EASTERN CORRIDOR SEGMENTS II AND III (PID 86462)

COMBINED LINWOOD/EASTERN INTERCHANGE & US 50/RED BANK INTERCHANGE FOCUS AREAS ADVISORY COMMITTEE MEETING NOTES

February 14, 2018
May 22, 2018
September 7, 2018
December 12, 2018

Figure EW-1
RECONNECT BEECHMONT COURT

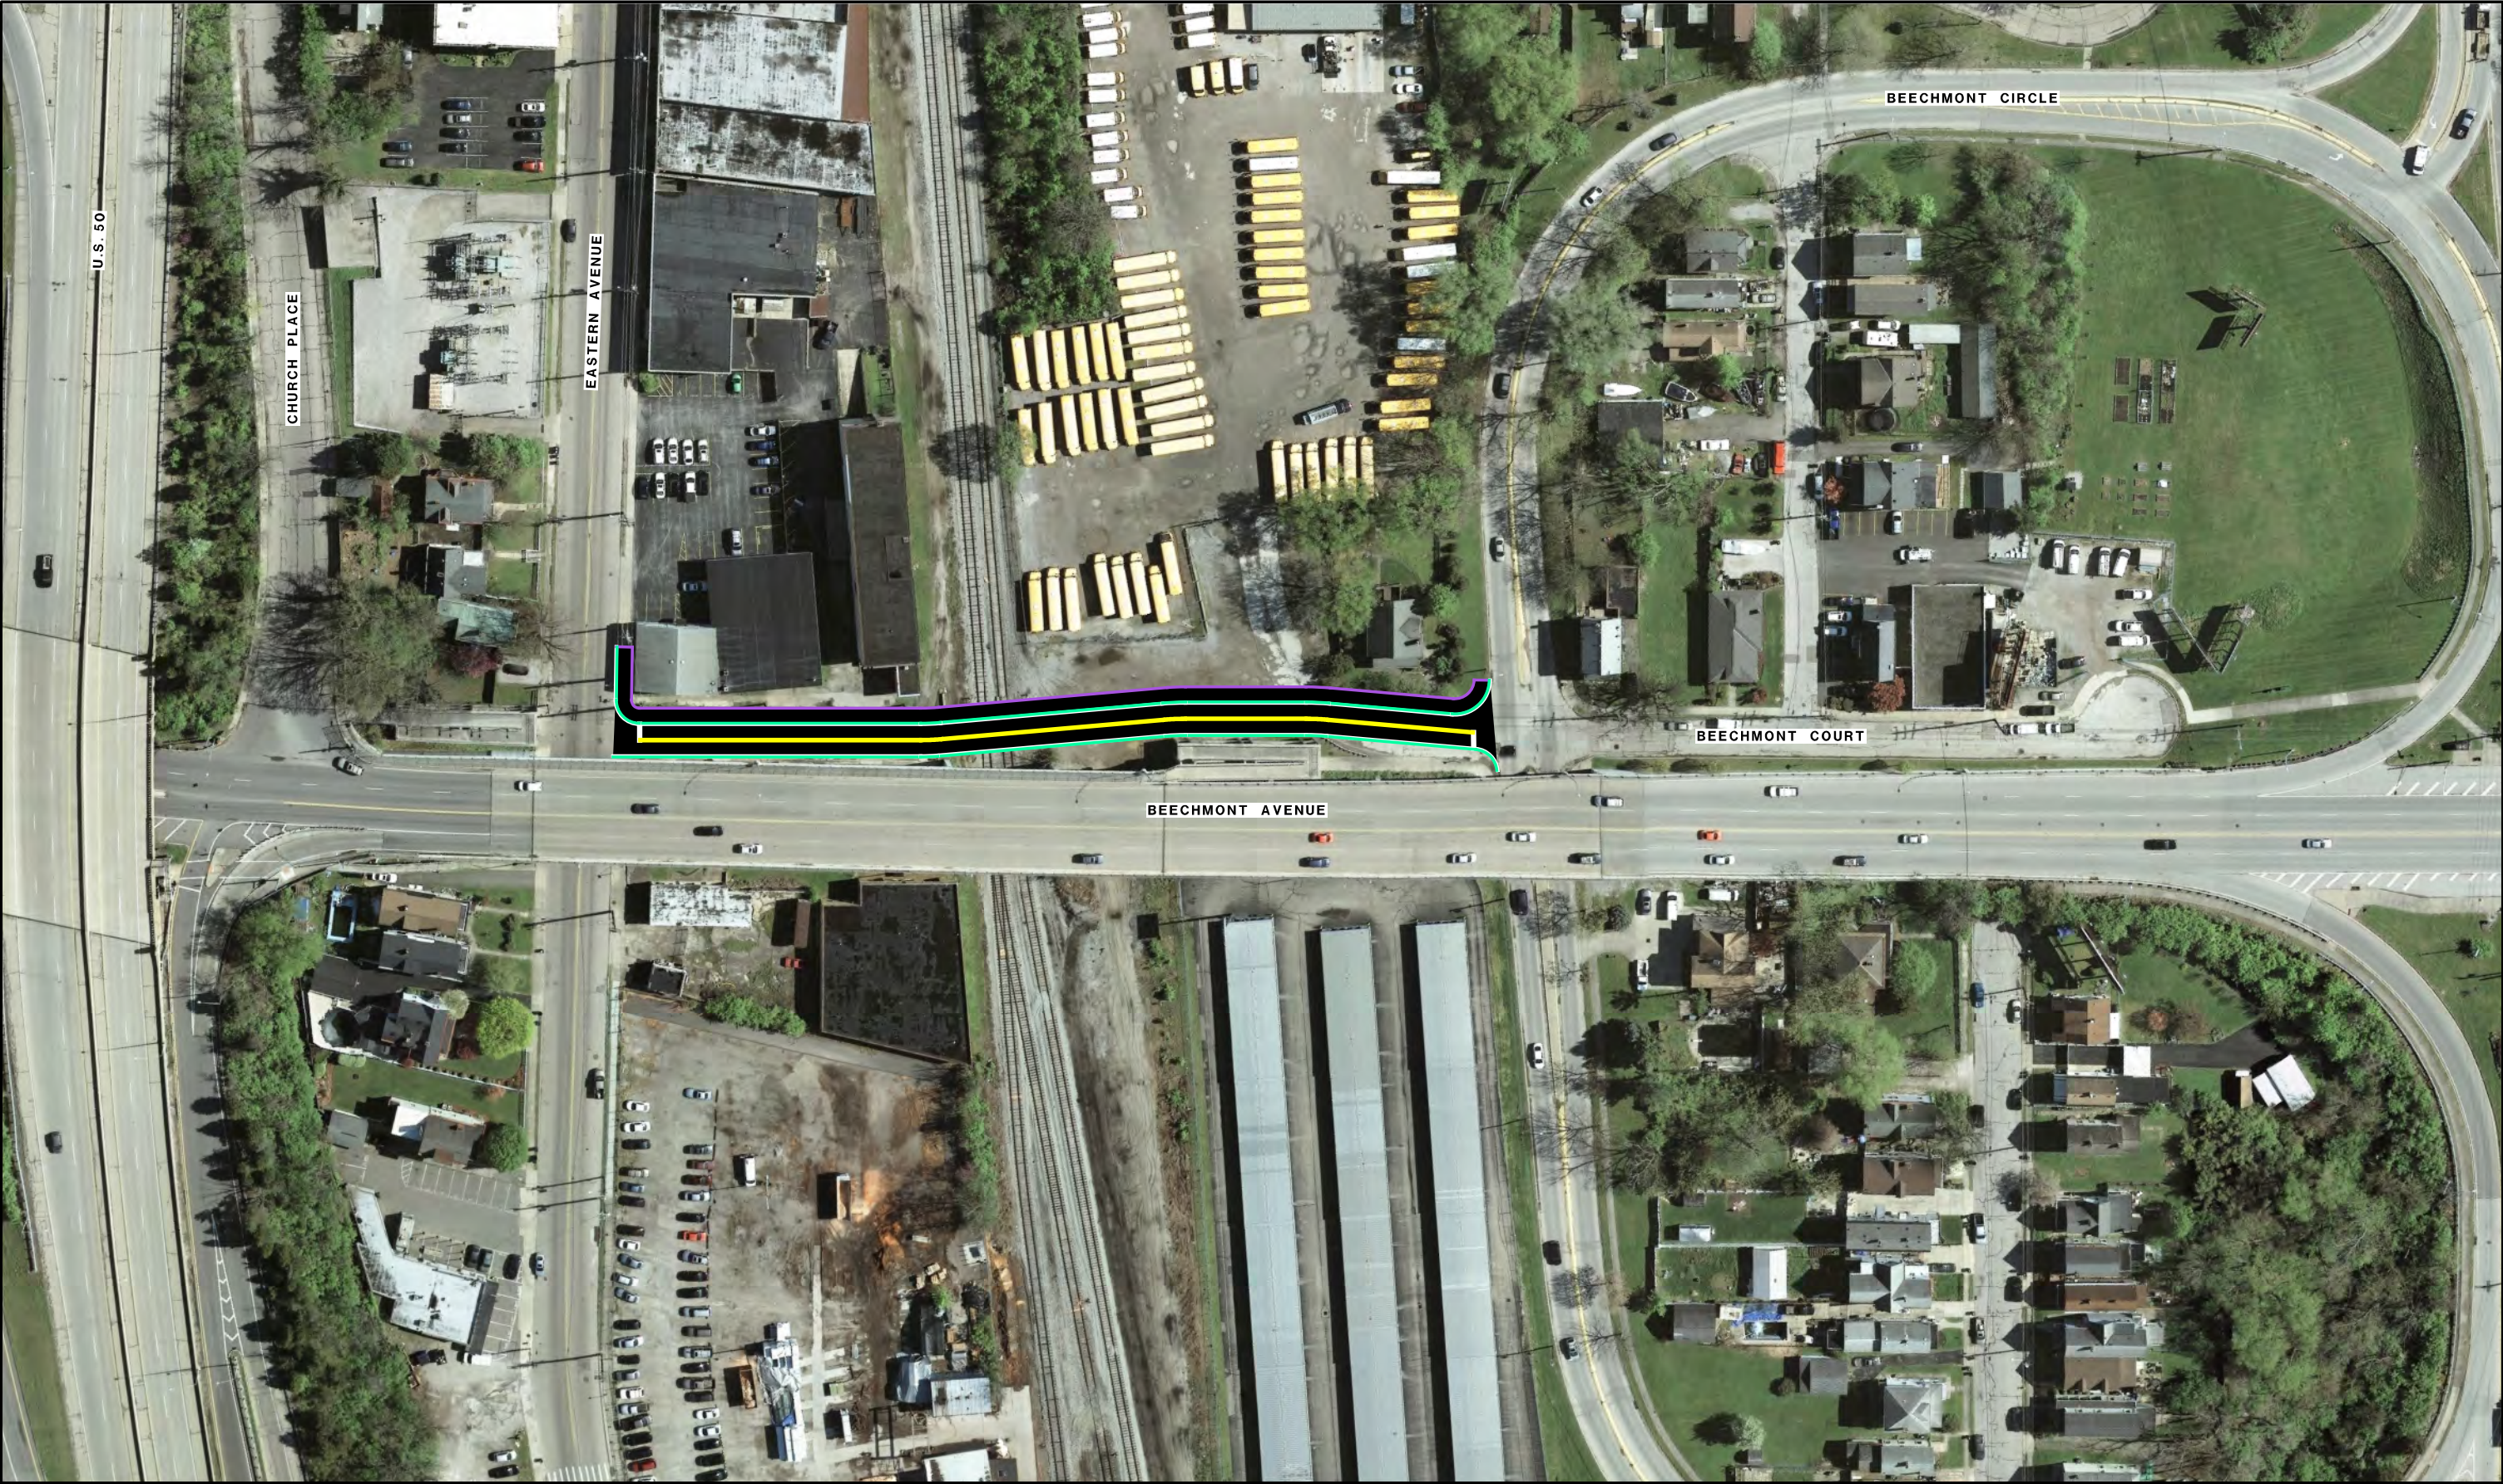
- Concept would require an at-grade railroad crossing, which may be difficult to negotiate with the rail companies.
- SORTA might have a service plan that goes through this area and it’s possible that the railroad tracks would be eliminated. J. Gardocki will confirm and report back to ODOT.
- The proposed new road in this concept is very close to the bridge to the SR 125/Beechmont Levee, which would impair visibility for the railroad.
- Concept drops traffic directly into the Beechmont Circle.
- Bike connections are better addressed through other concepts.
- No additional comments received following the 5/22 meeting.

- No further study because:
 - Traffic flows into the middle of Beechmont Circle, further segmenting the residential area.
 - Railroad may not allow a new at-grade crossing.
 - Close proximity of the road to the bridge may cause sight distance issues.

RECOMMENDATION: NO FURTHER STUDY
